Energy Networks Australia response to Low Energy Homes modelling – Cost Benefit Analysis

Energy Networks Australia welcomes the opportunity to provide this submission in response to the Trajectory for Low Energy Homes: Cost Benefit Analysis report (Report) questions.

Figure 1: Modelled Energy Savings (Source: Cost Benefit Analysis Report, Figure 1).

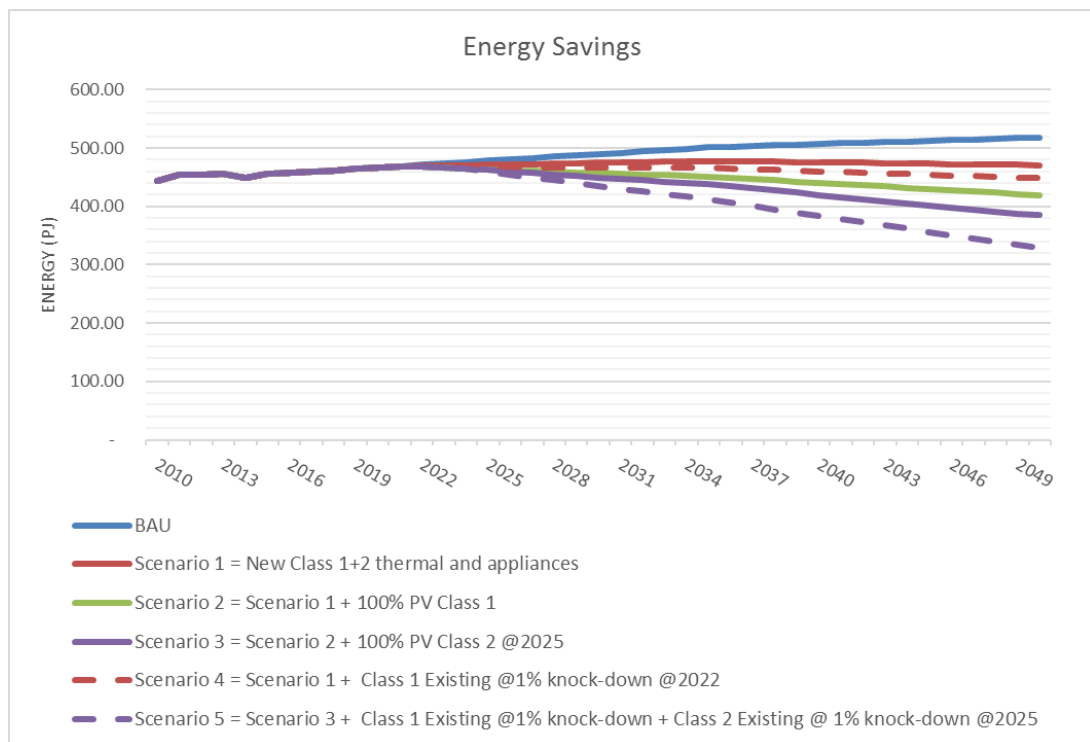
Additional energy savings are modelled with the increasing savings over time. The results indicate that additional energy savings are made when 100% solar PV offset is used. For example, the only difference between scenarios 1, 2 and 3 are additional offsets with rooftop solar PV. The reported energy savings in 2050 are larger than those from improving the energy efficiency (savings between BAU and Scenario 1).

Offsetting energy usage does not imply increased energy efficiency of the home. Indeed, it could be argued that a home which installed excess rooftop solar PV could be considered to have massive energy savings but that relates to the energy generated by the home compared to that consumed. It does not relate to the energy efficiency of the home.

Furthermore, a hybrid home that uses gas, can similarly offset emissions from displacing coal fired electricity when installing solar rooftop PV, although that will not make any change to the actual energy efficiency of the home.

Energy Networks Australia recommends that energy offsets are excluded as part of the energy savings of Class 1 and Class 2 buildings, and that they are excluded

from the Cost Benefit Analysis. Energy savings should be limited to the actual energy consumed during operating the home.

Figure 2: Cost reduction rates for hot water (Source: Energy Networks Analysis of Cost Benefit Analysis Report)

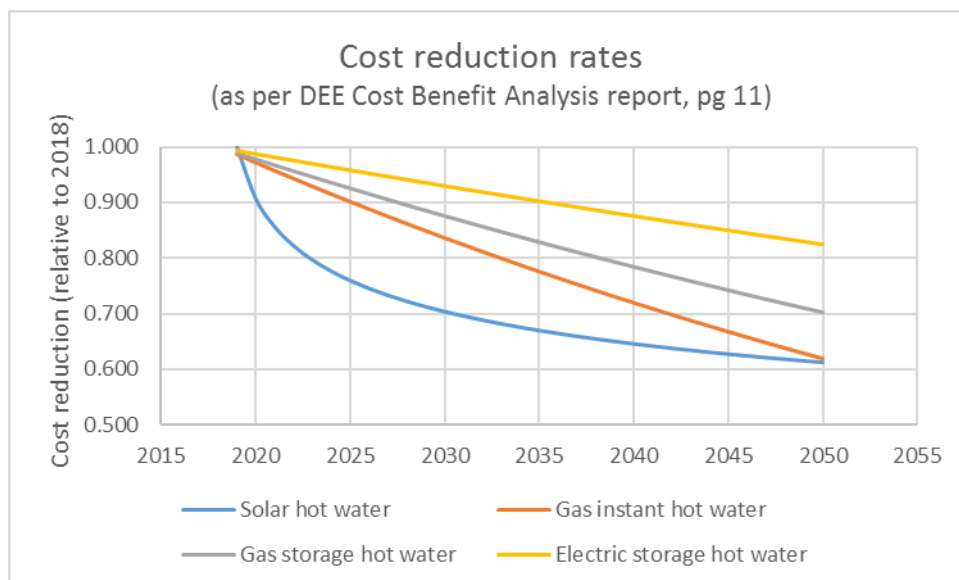
It is unclear why the learning rates for hot water systems have a different form for solar heat compared to other technologies. One is a power function while the other are exponential decays. These learning curves have been recreated in the diagram below by comparing the relative cost reduction from 2018 prices out to 2050.

As can be seen, the assumptions in the report indicate that the cost of solar hot water reduces much faster than instant hot water gas although both reach the same level of cost reduction by 2050. The cost reductions of storage hot water systems are slower.

These assumptions would lead to a much higher NPV for the solar hot water as its costs reduce more in the next decade and that has a greater impact on NPV compared to the cost reductions in the 2040 to 2050 timeframe.

Energy Networks Australia recommends that this apparent bias favouring solar hot water is addressed in the cost benefit analysis.

Figure 3: Capital cost reduction of power generation technologies (Source: Global CCS Institute - <https://hub.globalccsinstitute.com/publications/co2-mitigation-potential-and-cost-analysis-ccs-power-sector-guangdong-province-china/32-technical-setting-model>)

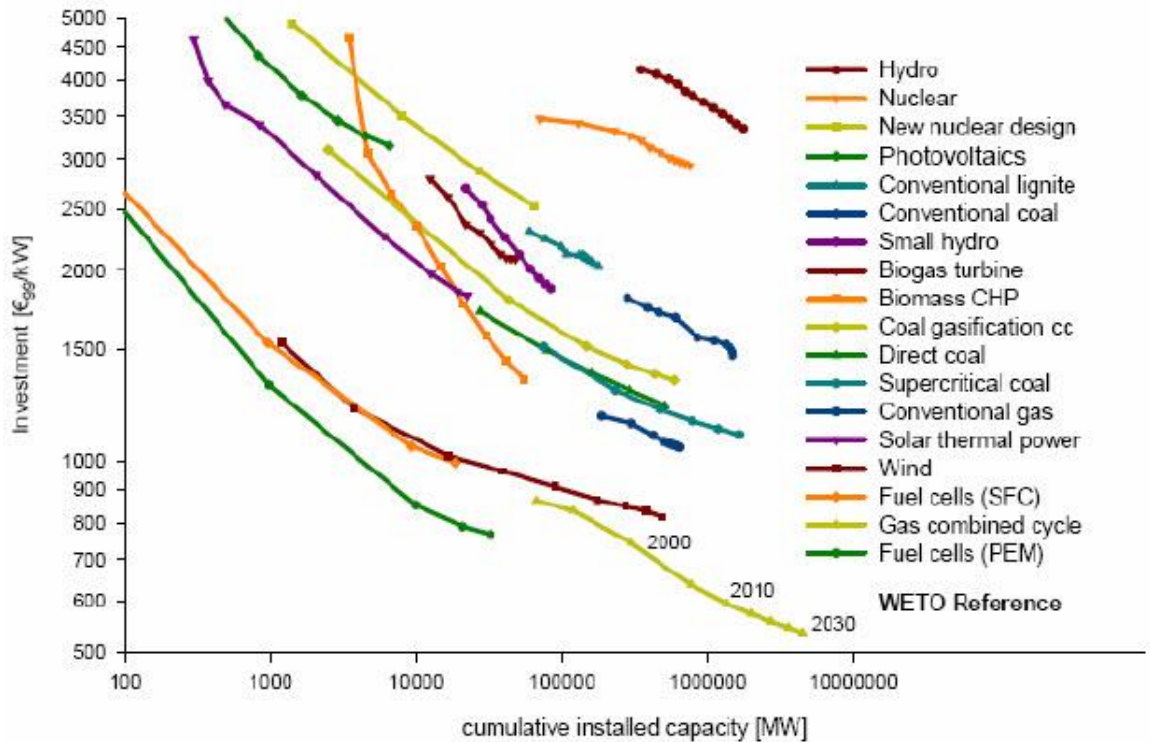
Furthermore, cost reductions are generally measured against installed capacity and not by year. As shown in the figure of the Global CCS Institute below, all technologies reduce costs in a similar manner. Hence it is unclear why the

Department has adopted a different type of learning curve for solar hot water compared to the other hot water technologies, nor indeed, why it is modelling this against year, rather than total cumulative instalments.
